3.3 Refused Planning Application

3.4 Appeal and Layout Revision

3.5 Response to Inspector's Comments

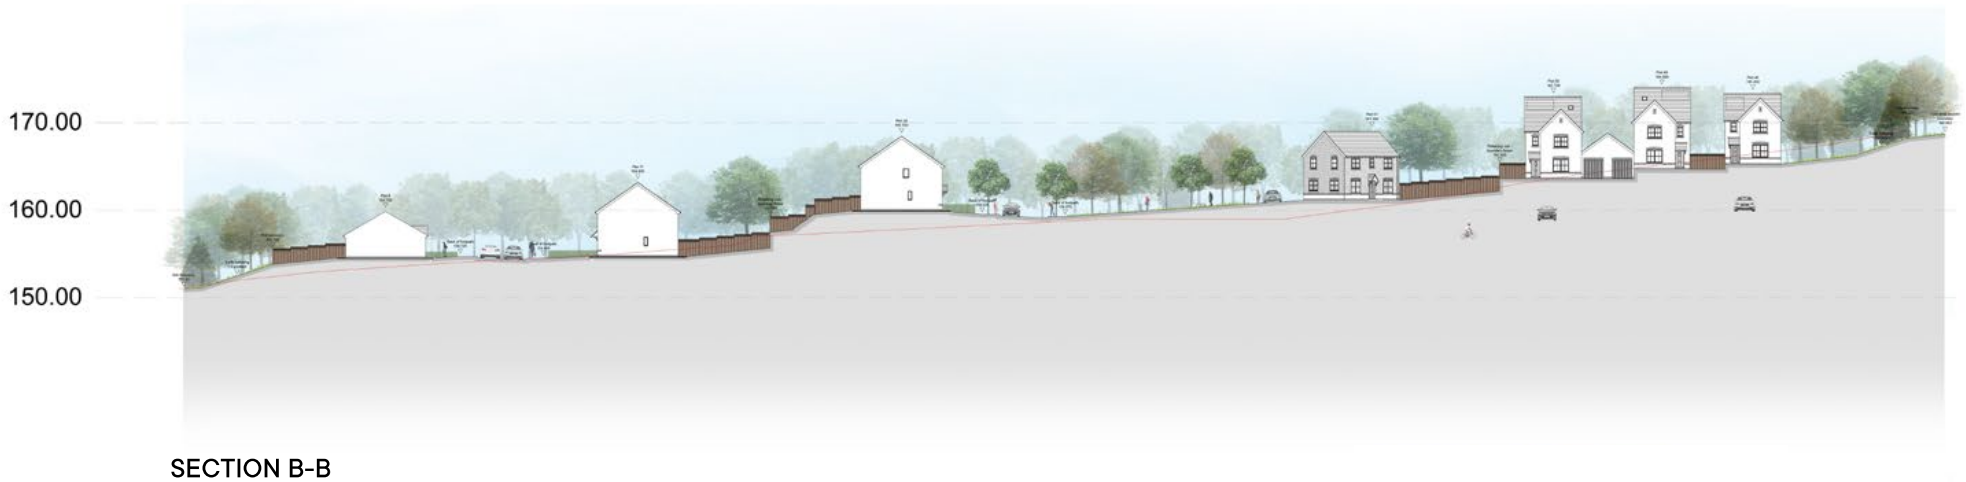
- ① Northern area revised to create a more organic layout to address Council's comments upon refusal
- ② Plot arrangement revised to allow for greater landscape buffer to western edge to address the Inspector's concerns regarding landscape and visual impact mitigation
- ③ Eastern landscape buffer increased to allow for greater landscape and visual impact mitigation as raised by the Planning Inspector
- ④ Revision of plot and typology to allow for semi-detached 2.5 storey dwellings as suggested by Inspector

This comparison shows the key areas that have been amended to address the Inspector's comments within the appeal decision.

Response to para. 17 showing amended earthworks strategy with sloped banks introduced to ensure a softer interface with adjacent land and reduce visual impact.

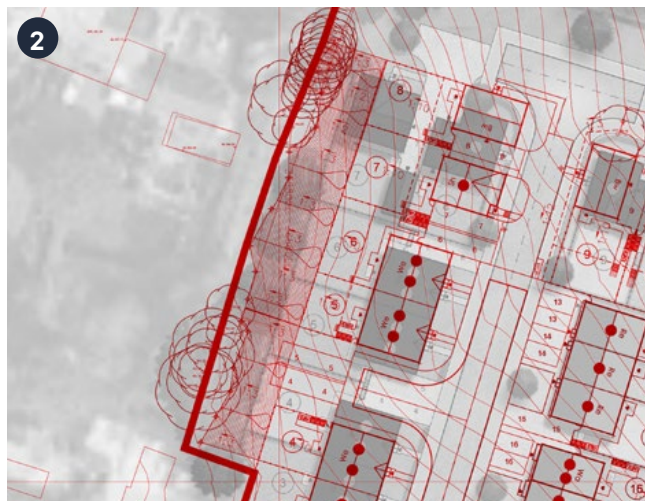
Appeal decision paragraph	Design Team response and amendments
Para 16. The Council's concerns relating to the northern part of the site centre around the significant changes to landform. It is inevitable, due to topography and geology of the site, that in order to achieve the proposed layout significant earthworks and extensive retaining structures would be required.	As stated by the Inspector the nature of the site in respect of topography means that earthworks are inevitable to achieve development. However, the design team have spent additional time since the appeal decision considering how improvements can be made to reduce retaining structures or, where used, reduce their visual impact.
Para 17. Consequently the approach across the scheme would be to address levels within individual parcels in different ways, and in the northern area, split, level-dwelling and gardens, along with landscaping where level changes would otherwise be particularly apparent. The appellant's evidence indicates that dwellings to the east of the northern access road would generally include a retaining structure along the rear garden boundary. Gardens to the west of the access road would be tiered and would incorporate, for the most part, a retaining feature between the upper and lower gardens between the lower garden and adjacent land.	The amended proposals adopt a similar approach as demonstrated in other parts of this DAS however the retention between the lower garden and adjacent land has been modified to create a sloped bank as demonstrated in section A-A to ensure a softer interface with the adjacent land and mitigate against the visual impact of this retention.

Response to para. 20 showing amendment to rear gardens to plots 4-8 to replace retaining wall with earthworks battering in this area to assist with relationship to existing dwellings and allow for retention of existing trees.

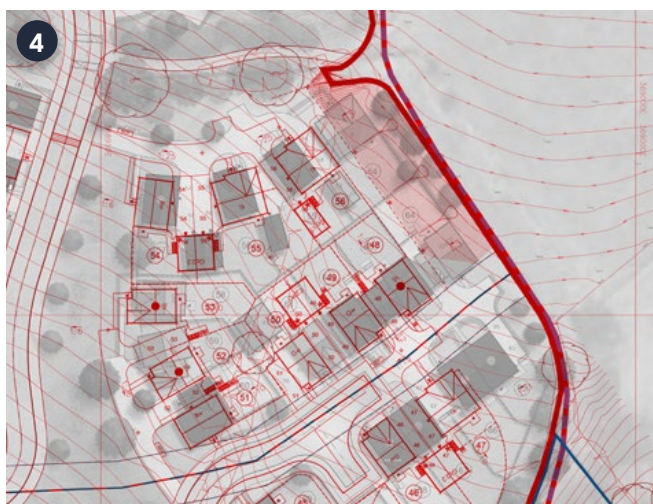
Para 18. The retaining structures and dwellings would be clearly visible, particularly in close views from properties to the west of the site on Wilpshire Banks where the dwellings would be at much higher land levels. It would take time for the proposed landscape buffers between these properties and the new dwellings to mature. Nonetheless, provided reasonable sized specimens were used within the landscaping scheme at the outset of planting, due to the distance, the visual appearance of the structure and dwellings would be lessened, as is the case with existing surrounding development. Should I be minded to allow the development this could be dealt with by the imposition of a suitably worded condition.	Persimmon are agreeable for a suitably worded planning condition to be applied by the LPA.
Para 19. Notwithstanding the above, higher retaining structures would be constructed within other areas of the site close to the boundaries where it has not been clearly demonstrated there would be sufficient space to accommodate landscaping to screen the structure and / or the proposed dwellings. This would be particularly evident to the rear of several plots.	The proposed layout has been amended to reconfigure the plot arrangement on the western boundary (see extract 1) to increase the width of the landscape buffer and reduce the number of units thereby allowing for an improved relationship with existing properties to the west.

Para 20. From the evidence available, in order to ensure an acceptable road gradient, the proposed two storey dwelling at Plot 7 would be approximately 5m above the land level at the boundary of the site with the rear garden of 22 Whalley Road (No 22), and would include a 3m high retaining structure with a close boarded fence above. I observed the tall evergreen trees along this boundary are located within the garden of No22 and their retention cannot therefore be guaranteed to screen the proposed development. Although two silver birch are located with the appeal site close to this boundary, the appellants arboricultural information identifies these would be removed to facilitate the retaining structure requirements. As such, I find the limited separation to the boundary in combination with the proposed tall retaining feature and level difference to the dwelling of plot 7 would result in a cramped and incongruous layout in the part of the site, out of character with the prevailing building pattern.	The layout has been significantly amended on this part of the site pulling the rear garden boundaries for plots 4-8 away from the western edge thereby allowing for a larger sloped buffer and avoiding the need for a retaining wall (see extract 2) and fence above. This will improve the relationship with 22 Whalley Road and ensure that the two silver birch trees referenced by the inspector are retained. In summary the increased separation through the enlarged buffer and repositioning of garden boundaries combined with the profiling of the earth and the removal of what was previously plot 7 and relocation within the revised layout results in an improved relationship with the properties to the west and addresses the concerns specifically raised by the Planning Inspector.

Response to para. 19 showing reconfiguration of western boundary plot arrangement to increase landscape buffer and improve relationship with existing properties.

Response to para. 21 showing revised layout and arrangements to plots 8-12 with revised retaining walls to provide a continuous building line and prevent the creation of an overbearing boundary feature.

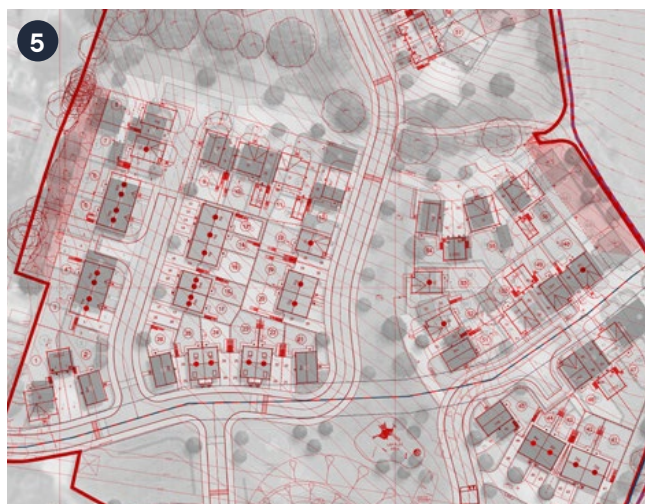
Appeal decision paragraph	Design Team response and amendments
Para 21. Turning to Plot 28 the proposed plans indicate a 2m and 3m high retaining structure surrounding the curved rear/side garden of Plot 28 with the driveway for Plot 11 adjacent at lower level together with an additional screen fence / wall above. On the basis of this information, this could result in an overbearingly high boundary feature which would be highly visible forward of the building line of Plots 7 to 11 and would face towards a pedestrian route and open space	A revised layout and arrangement is proposed which ensures a continuous building line between current plots 8-12 . This has been achieved by re-orientating plots and removal of a plot. Plots 9-12 have a finished floor level between 160.7 and 162.5 and the level difference between plots is accommodated through retaining walls that are less than 0.5m. A retaining wall runs along the side boundary of plot 9 which has a maximum height of 1.95m but this is obscured from views into the site by the dwellings further west. (see extract 3) The arrangement creates a clear continuous building line and avoids the previous issue flagged by the planning inspector in relation to the rear boundary of the previous plot 28 and an overbearing boundary feature.

Response to para. 22 showing amended earthworks strategy with earthworks battering replacing previous plots 54, 64 and 65 to allow for a larger buffer to the eastern site boundary and adjacent PRoW.

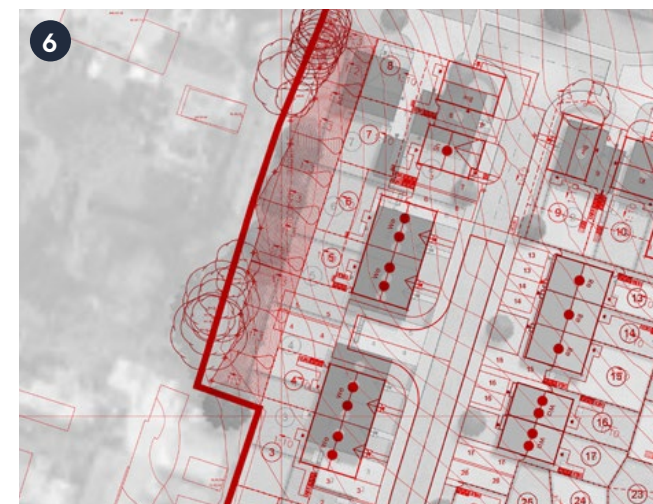
Para 22. Plots 54,64 and 65 would be sited close to the central eastern boundary of the site and land reprofiled with tall retaining features to accommodate the plots. However, the layout would fail to provide a sufficient landscape belt to define the settlement edge and provide an appropriate transition between built development and the open countryside in this area. PRoW 25 runs along the boundary of the site directly parallel with these plot boundaries on the opposite side of the drystone boundary wall. Due to the small gap, extensive earthworks and the abrupt change in levels, there would be limited opportunity to provide meaningful landscaping in this area, a highly sensitive part of the site.	The amended earthworks strategy ensures that there are limited features for these plots with the use of earth banking up to the eastern edge of the site. Previous plots 54, 64 and 65 have been removed thereby ensuring a much larger buffer with the eastern site boundary thereby addressing the concerns with regard to the PRoW and it's close proximity to the gables of these properties. This amendment to the layout plan ensures a 15 metre buffer which will provide a landscape buffer and ensure that the development has an improved and positive relationship with regard to PRoW 25. (see extract 4)
